**Sandlewood Food Pantry
8 August Lane
Final
Response Letter to Conditions
November 12, 2025
DRB-001075-2025**

Project Narrative for Sandalwood Community Food Pantry

The attached are the responses to DRB's conditions of the approval for DRB-000981-2025

**Sandlewood Food Pantry
8 August Lane
Final Set Plan Set
November 12, 2025
DRB-001075-2025**

ROOF PLAN

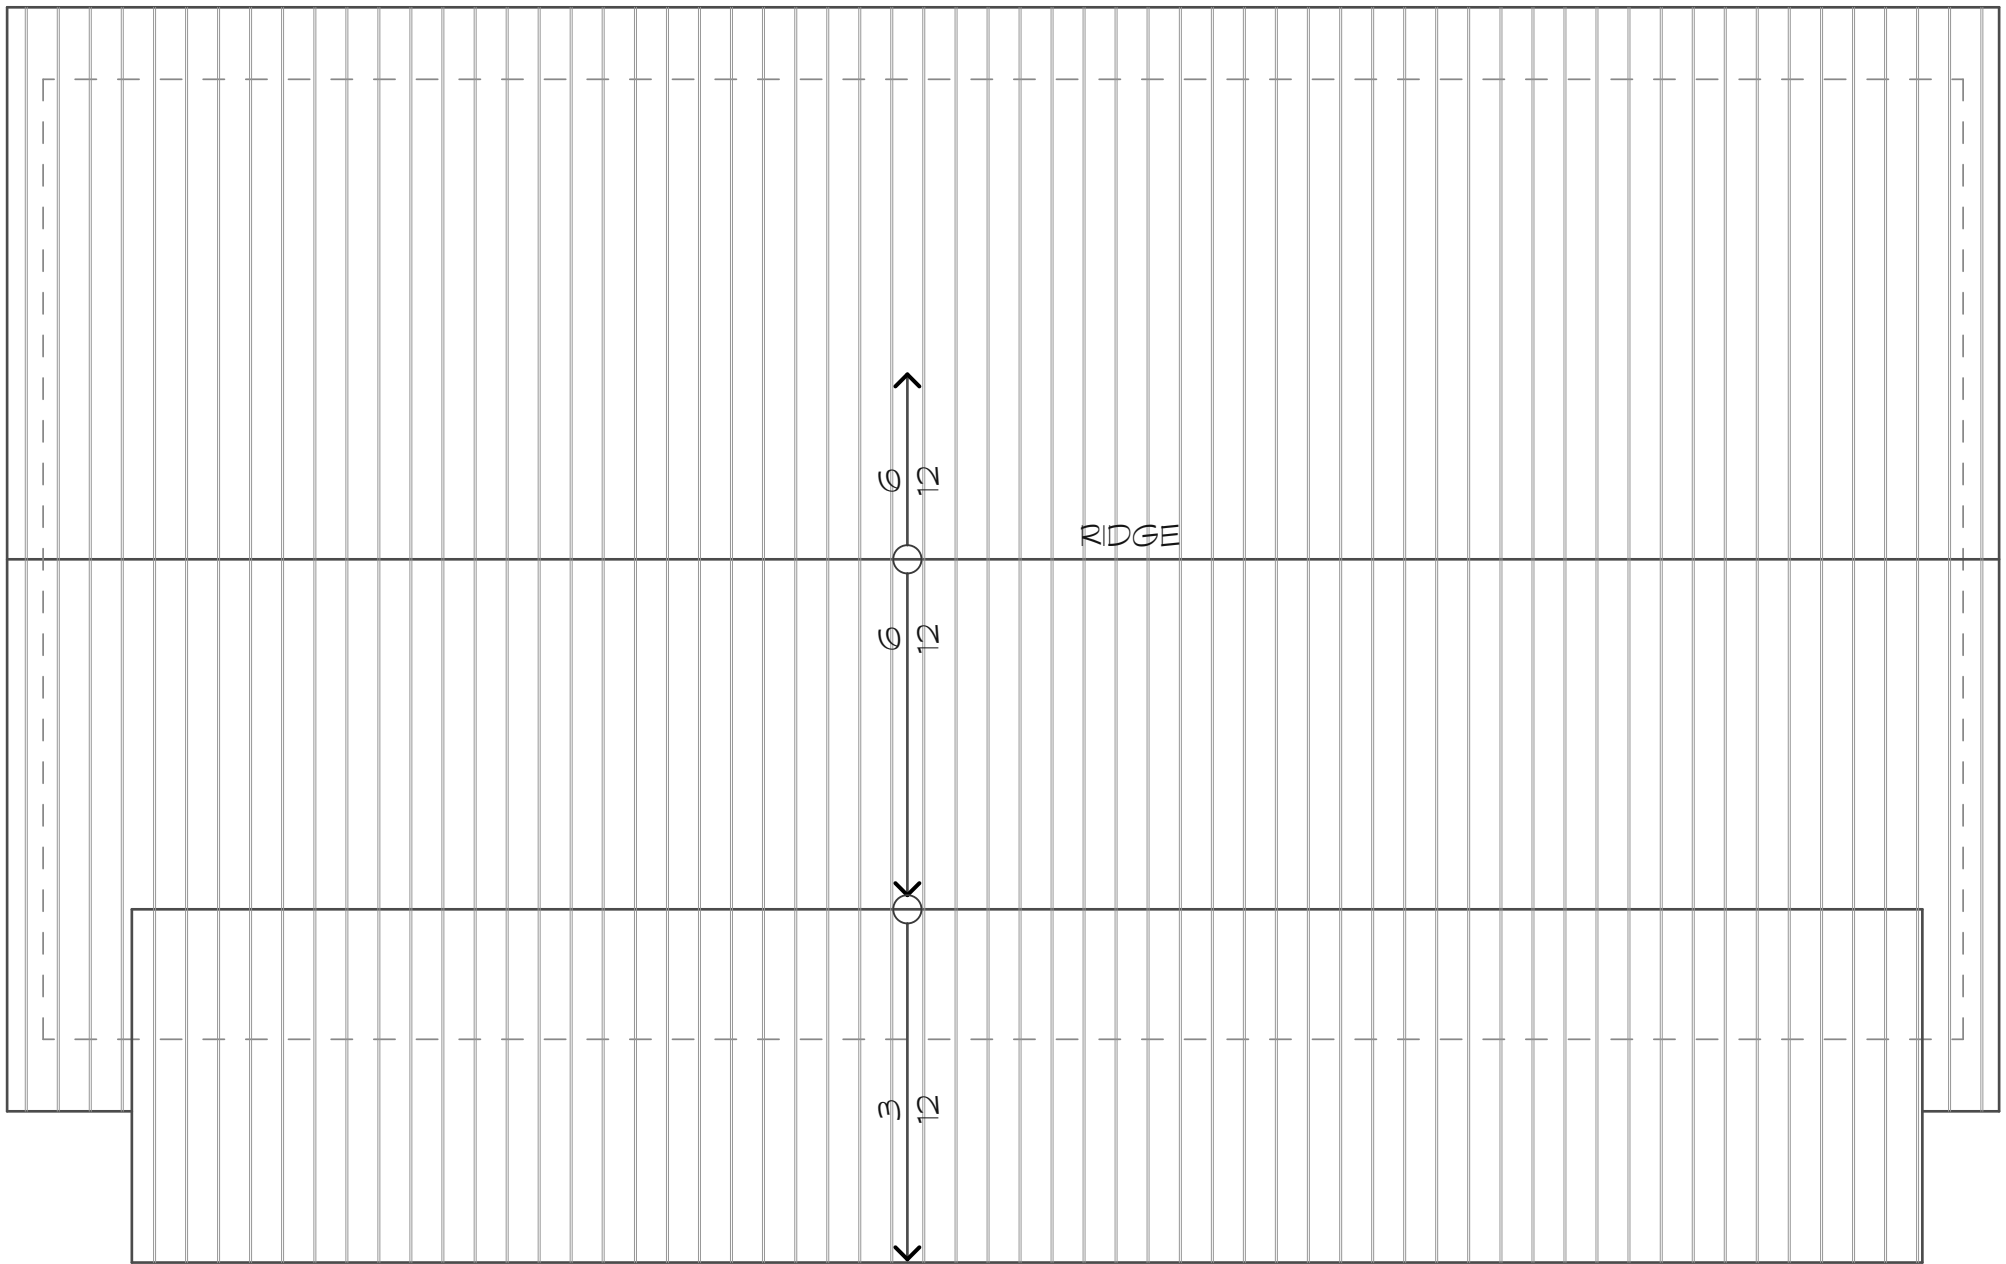
8. Provide a roof plan for the market. ***We are providing a roof plan for both the market and pavilion.***
9. Provide a photometric plan. ***We are providing a photometric plan for the site.***

SHEET NO.
C4.01

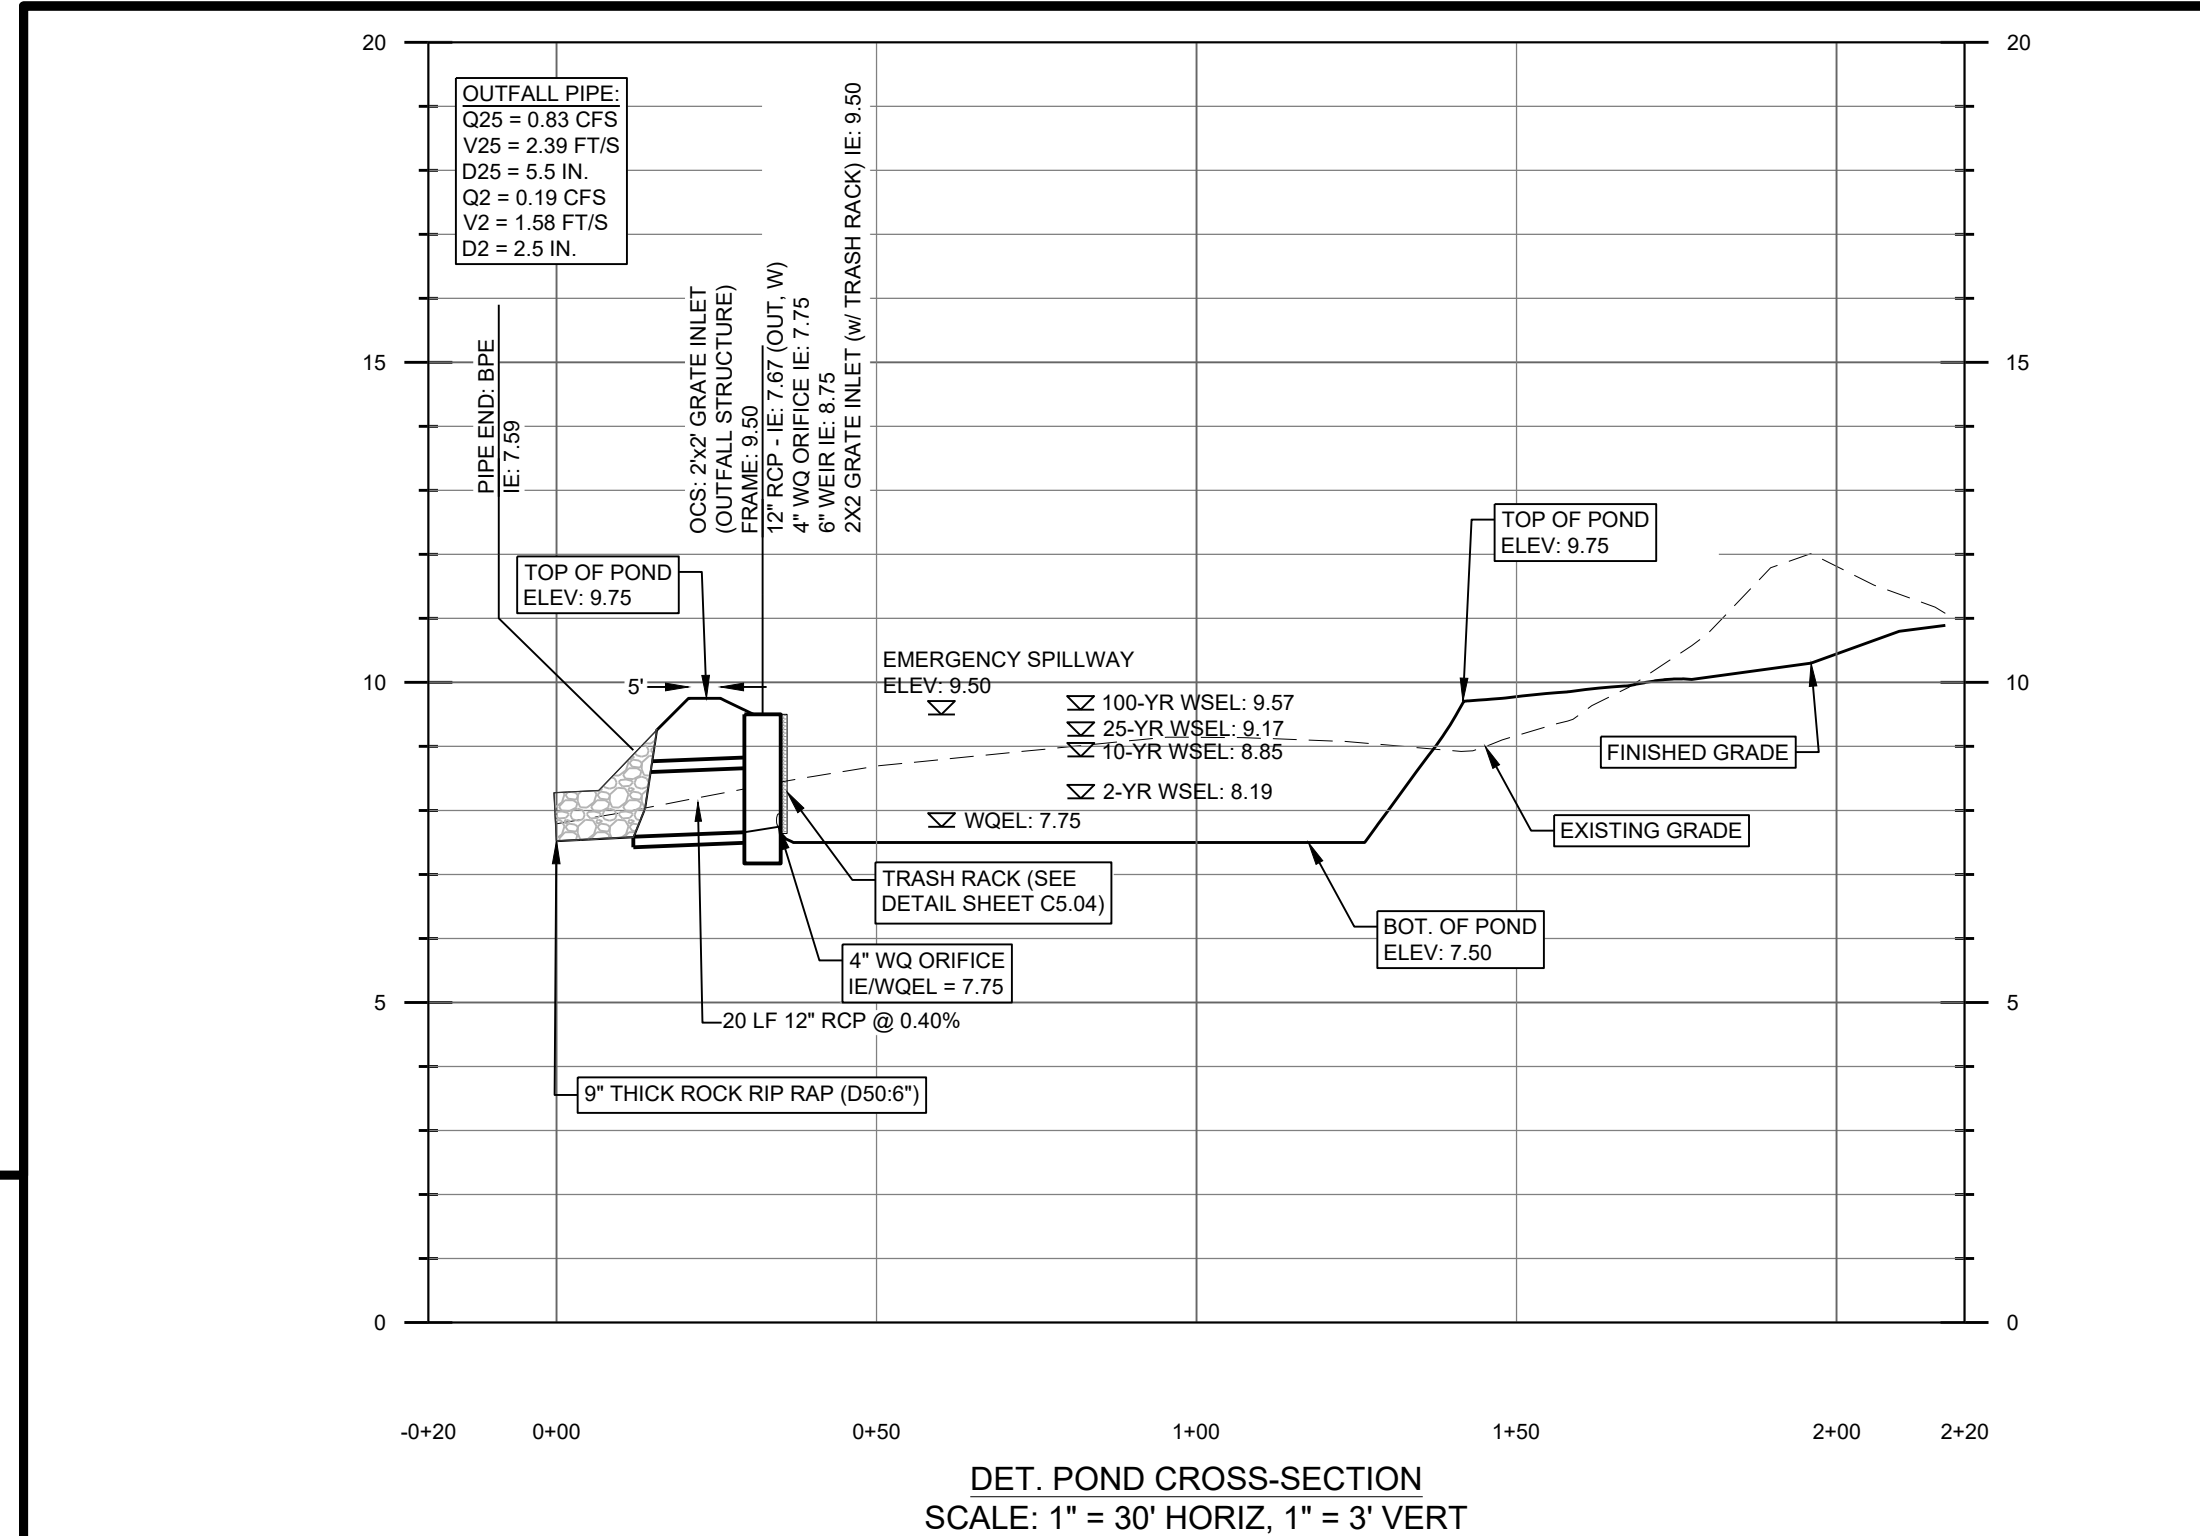
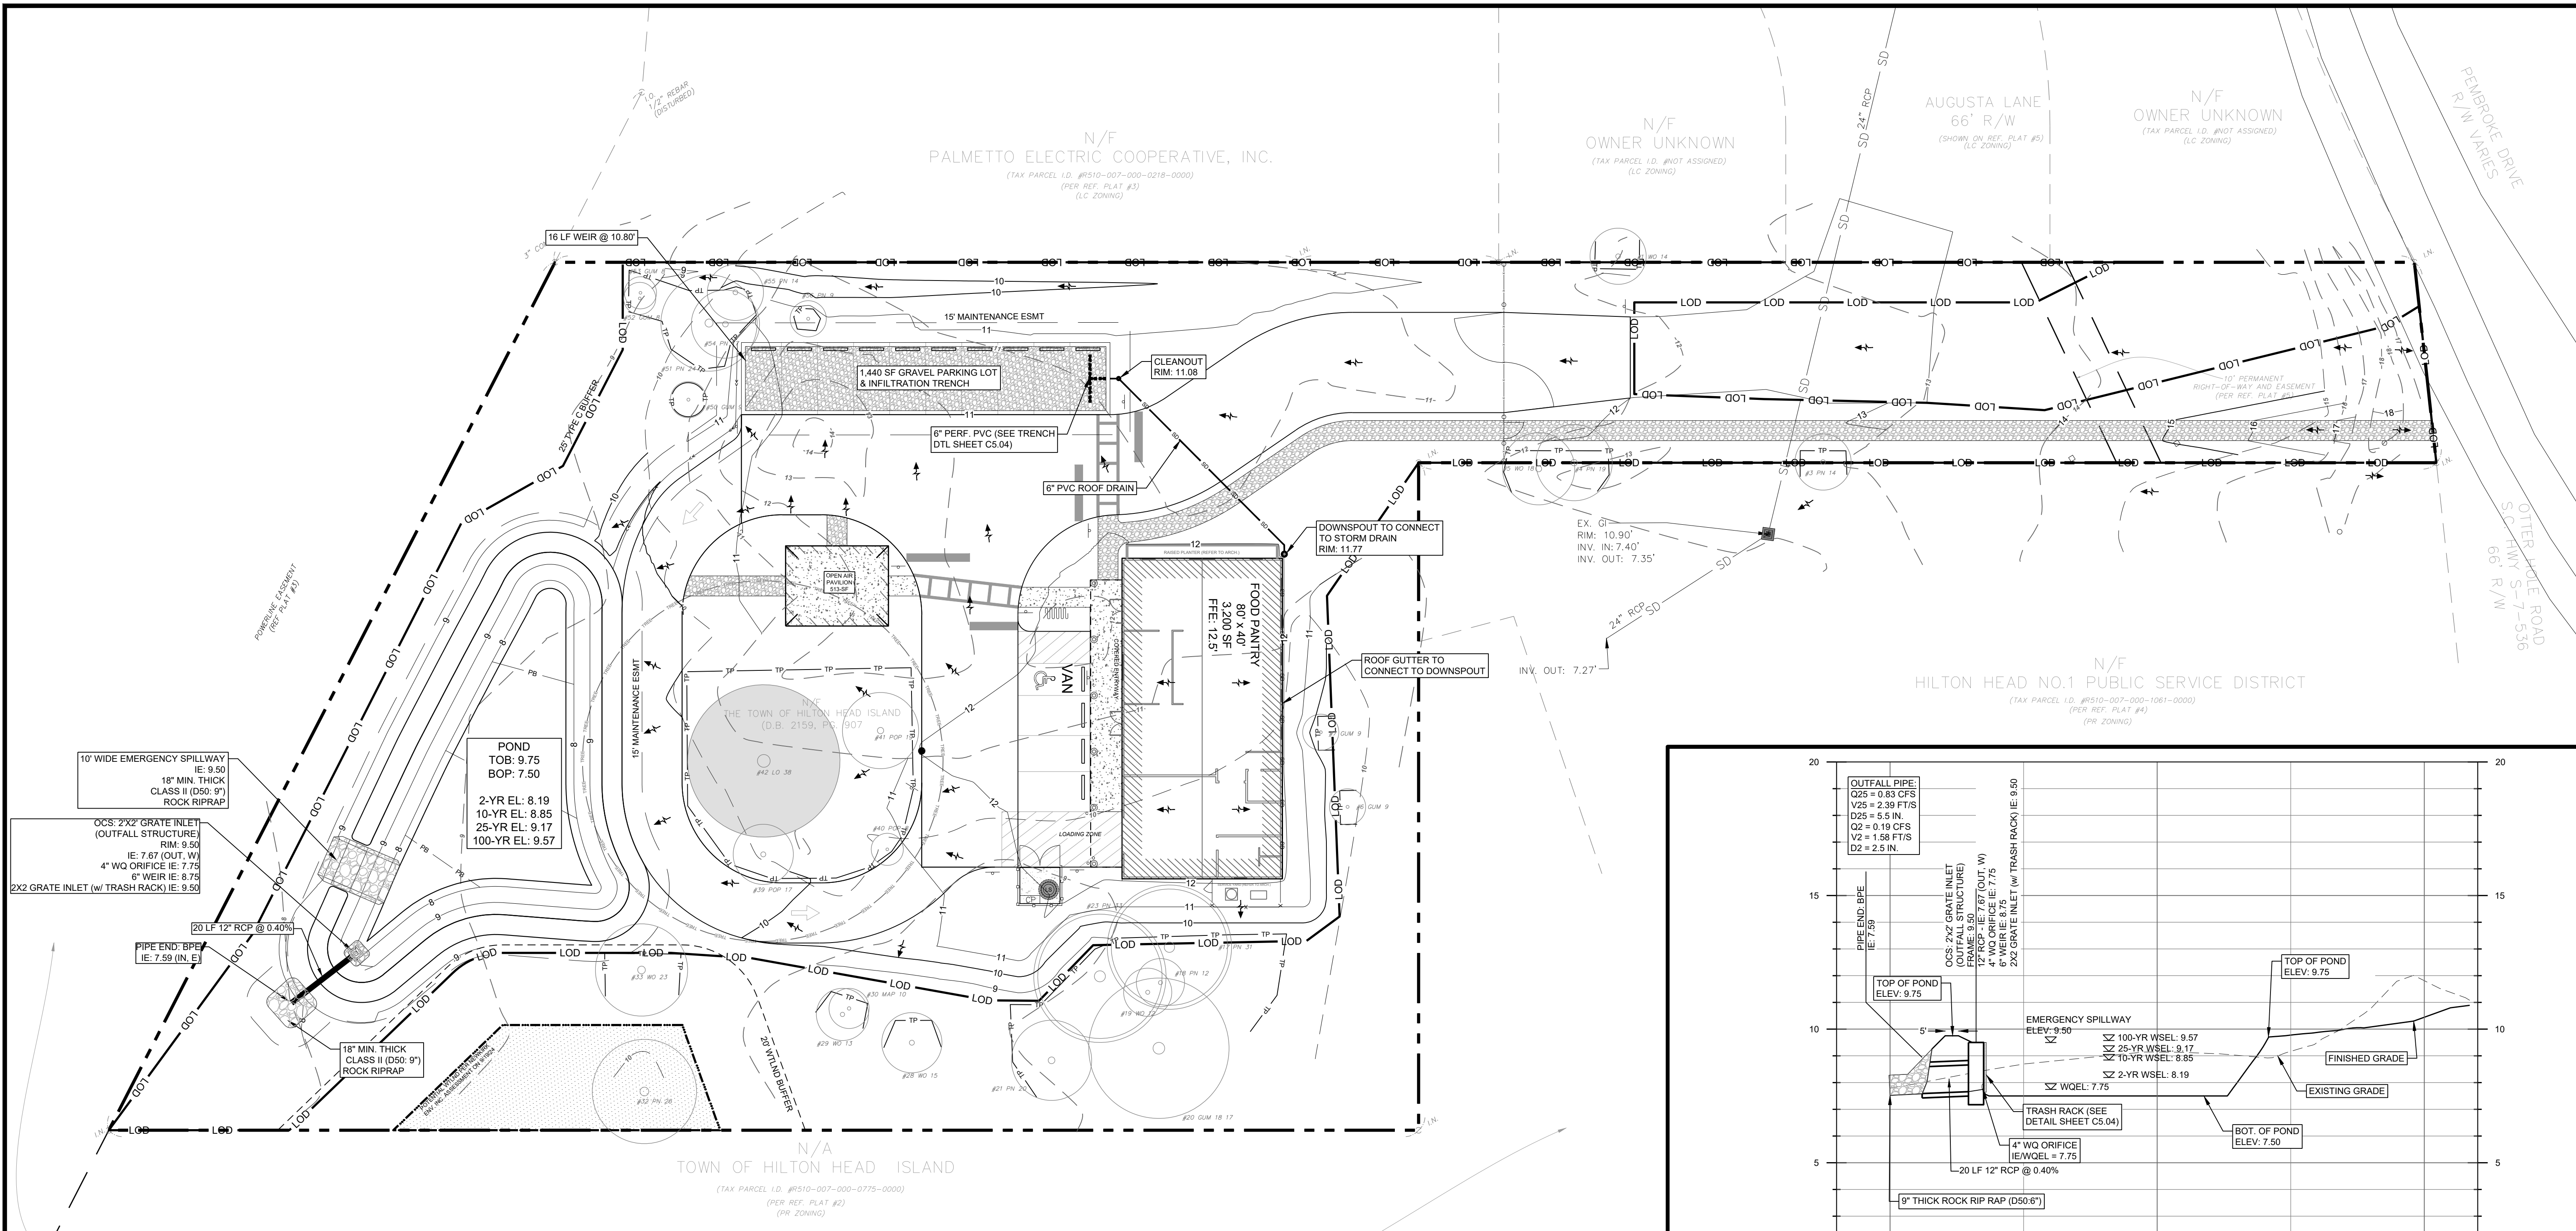
2. Consider a crosswalk for the parking lot. ***A crosswalk has been added that stretches from the adjacent pervious parking area and ties into the sidewalk next to the proposed building. Adequate pedestrian access should be available from all parking areas. See sheet C3.01 for crosswalk locations.***
